Approach Permit & 911 Address Form

HIGHWAY DEPT. USE ONLY	
Permit #:	65-08-18
911 Address:

Applicant/ Property Owner: Glen Ullin Energy Center, LLC		Current Mailing Address: 30 W Superior St, Duluth, MN 55802	
E-mail Address: jhollingsworth@allete.com		Daytime Phone or Cell #: 218-355-3249	
Lot:	Block:	Subdivision: Approach #2 Coordinates: 46.981256, -101.809177	Quarter: NE 1/4
			Section: 5
			Twp: 140
			Rge: 88

APPROACH - 20' WIDE TOP MINIMUM

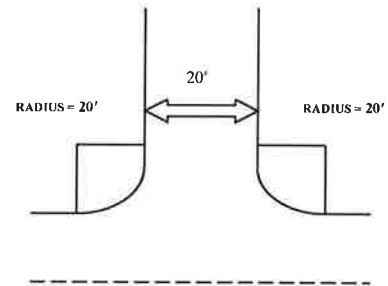
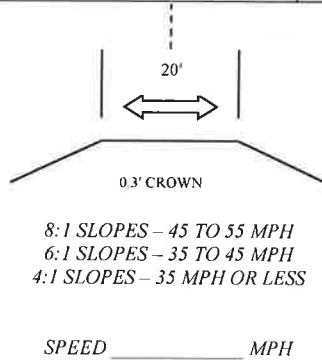
Culvert Comments: *At time of construction place a minimum of 1 foot fill over pipe and increase culvert length to correspond with desired approach top over 20 feet.*

Approach Comments: (Sight Distance? Problems? Etc.) *At time of construction place 4 inches gravel on approach.*
Inslope work required for 8:1 slopes
